City of Tacoma
Public Works Engineering Division

ADDENDUM NO. 2

REVISIONS TO:
Request for Bids Specification No. PW25-0153F
East Lincoln Ave Bridge

CITY OF TACOMA DEPARTMENT OF PUBLIC WORKS EAST LINCOLN AVE BRIDGE SEISMIC RETROFIT BEARING DETAILS (2 OF 2)	CTAC0090 SHEET NO. B-5 SHEET 5 OF 9
---	---

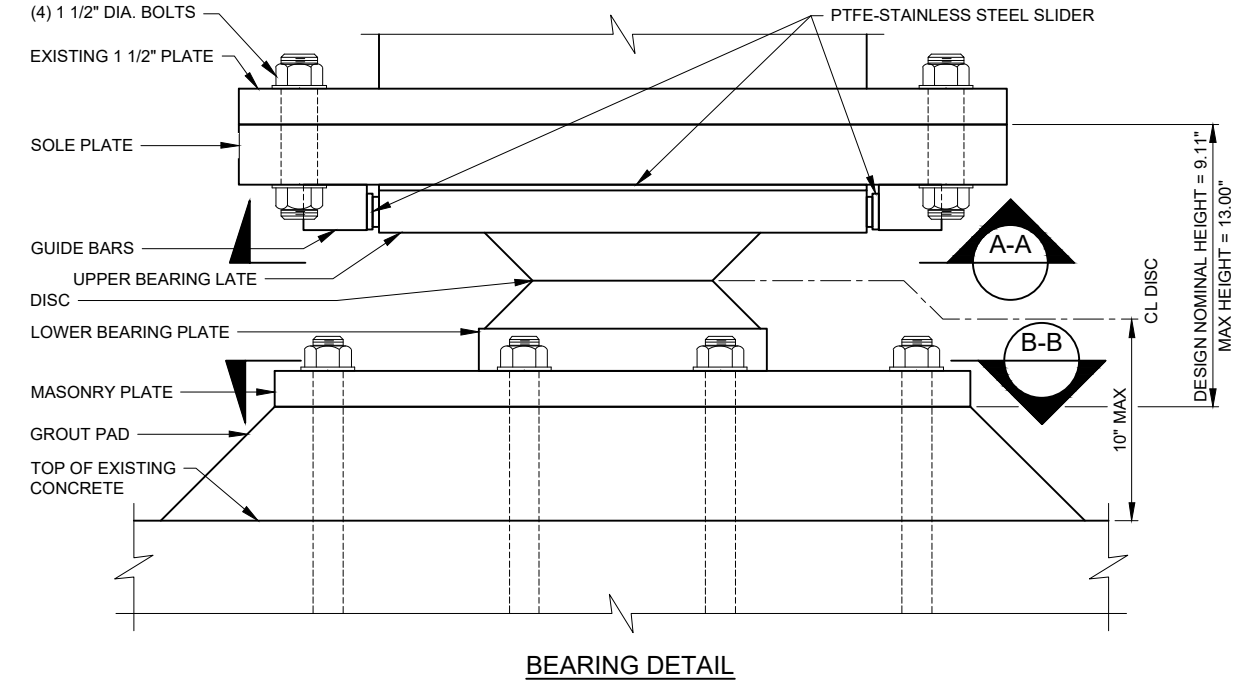
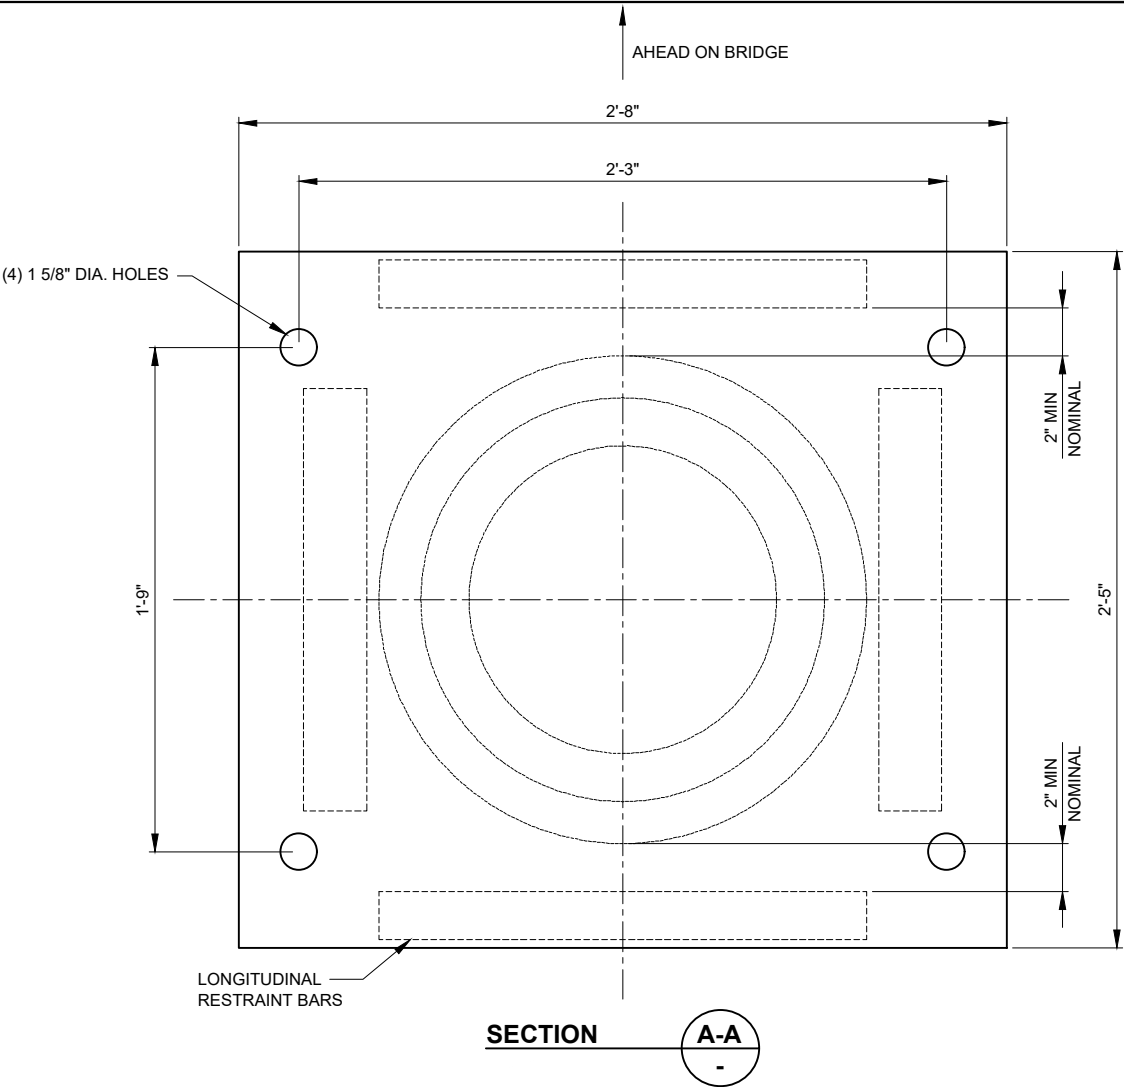
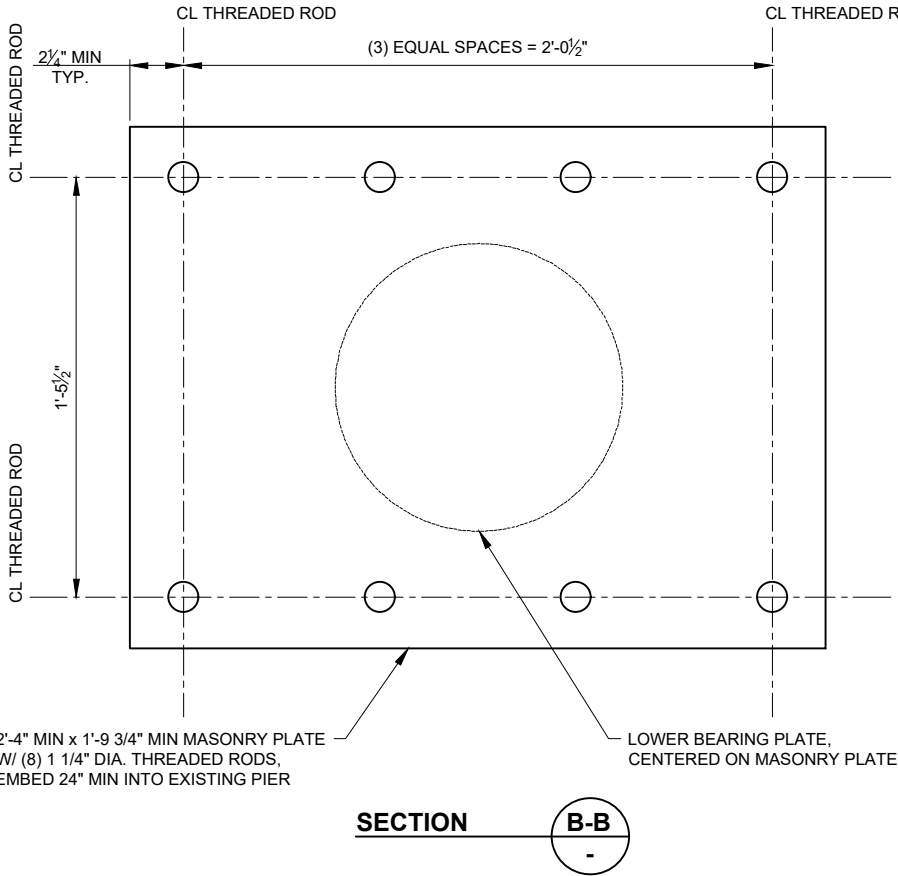
- 2. Question: Please clarify the service rotations and horizontal extreme event loads, it looks like there is a typo in the plans.**
Answer: Please see updated Properties Table in plan sheet B5 marked Addendum 2. Values are corrected for Horizontal Extreme Event and Service Rotation

6. Question: Please review the data table below from sheet B-5 of the contract drawings. I assume the Service Rotation value is incorrect and will be revised?

Answer: See Answer 2.

MODEL	DB375U
QUANTITY (EA.)	4
TOTAL LONG. DISPLACEMENT (IN.)	*+4.0, -3
TOTAL TRANS. DISPLACEMENT (IN.)	0.125
VERTICAL SERVICE (KIPS)	375.0
VERTICAL DEAD LOAD (KIPS)	262.5
VERTICAL STRENGTH (KIPS)	548.1
HORIZONTAL SERVICE (KIPS)	65.4
HORIZONTAL STRENGTH (KIPS)	66.0
HORIZONTAL EXTREME EVENT (KIPS)	~~80.0~~ 293.4
SERVICE ROTATION (RAD)	~~222.2~~ 0.015
STRENGTH ROTATION (INCLUDES +/-0.005 RAD CONSTRUCTION TOLERANCE)	0.0200
ASSUMED COEFFICIENT OF FRICTION	15%

DETAILS OF PIERS.

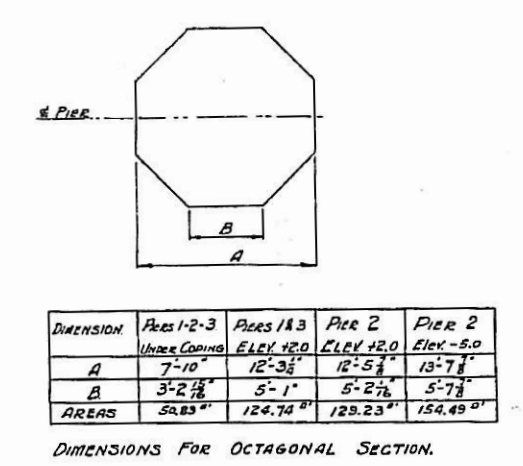
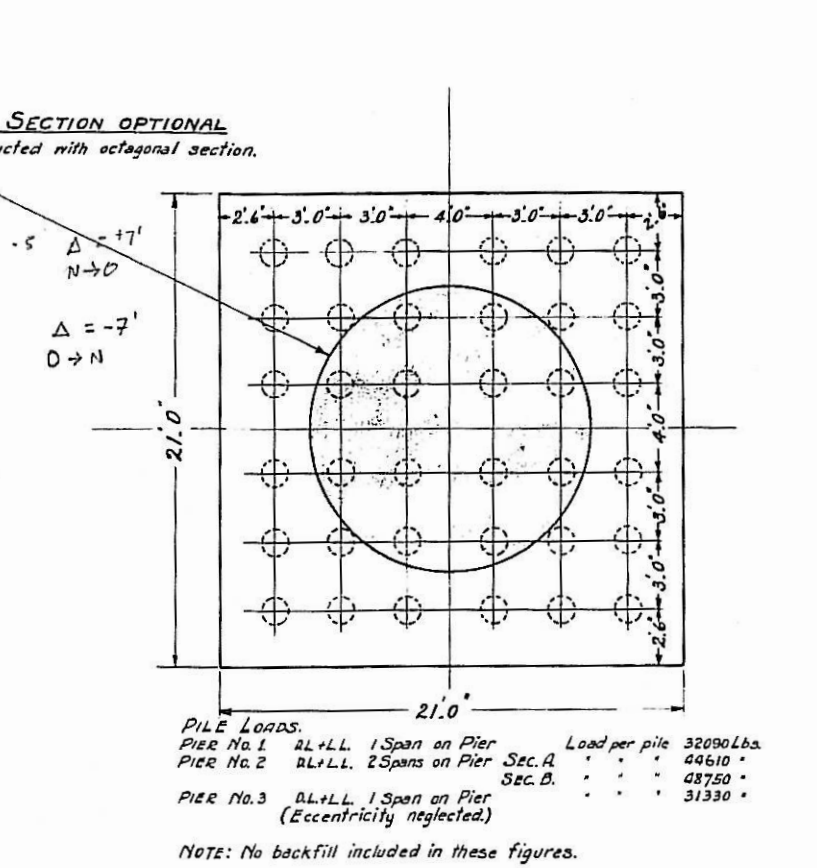
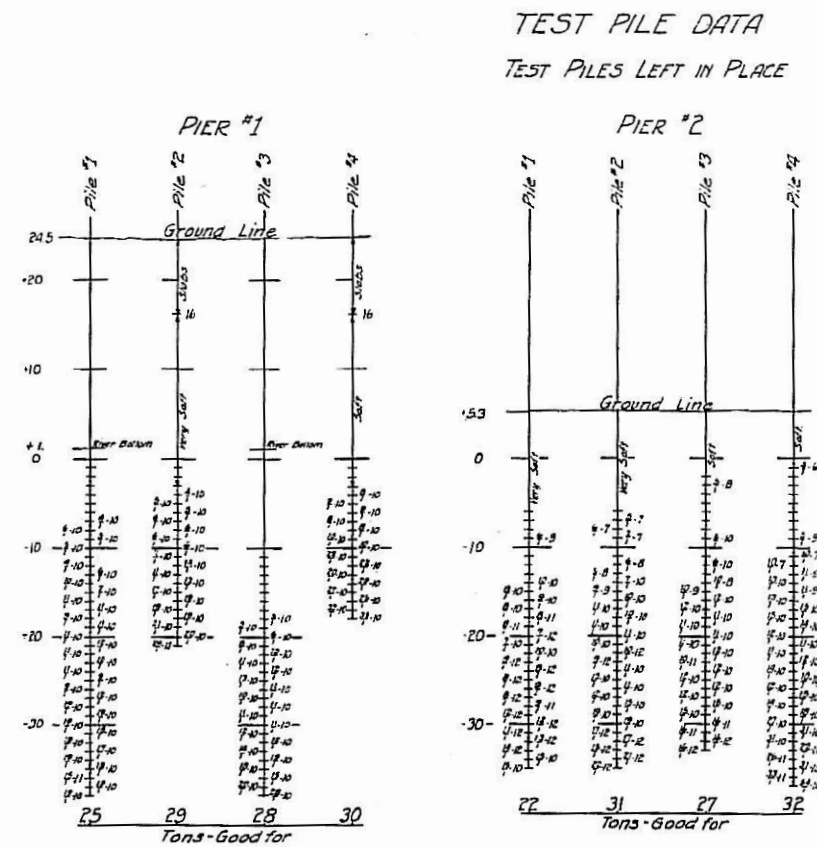
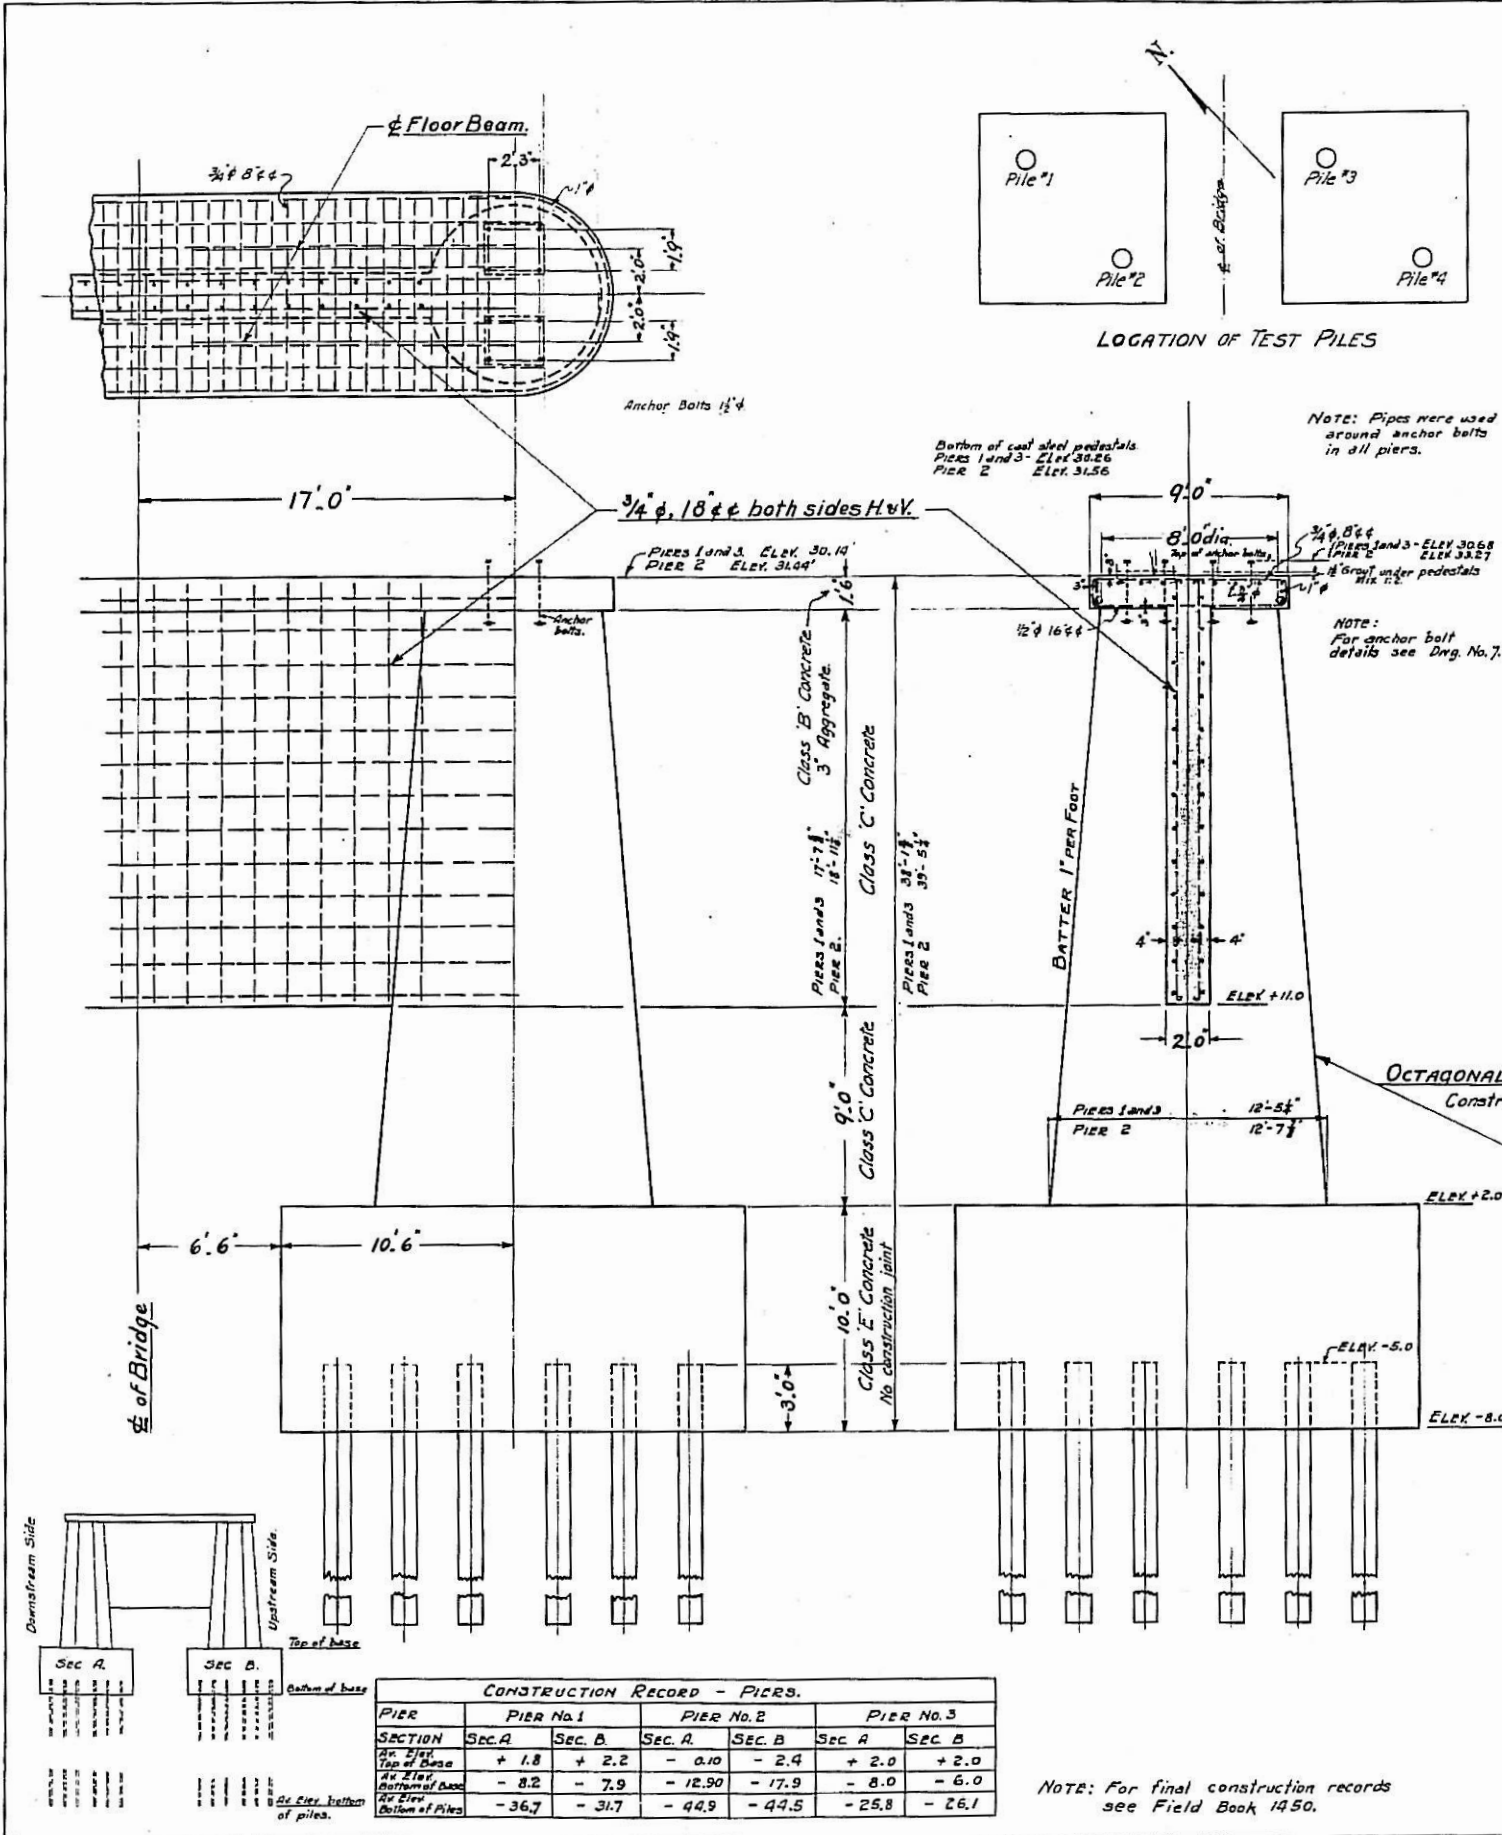
- 3. Question: Can we get a copy of the as-built plans for pier 3 abutment and bearing assembly?**
Answer: Yes, the as-built plans from 1929 are attached to Addendum 2.
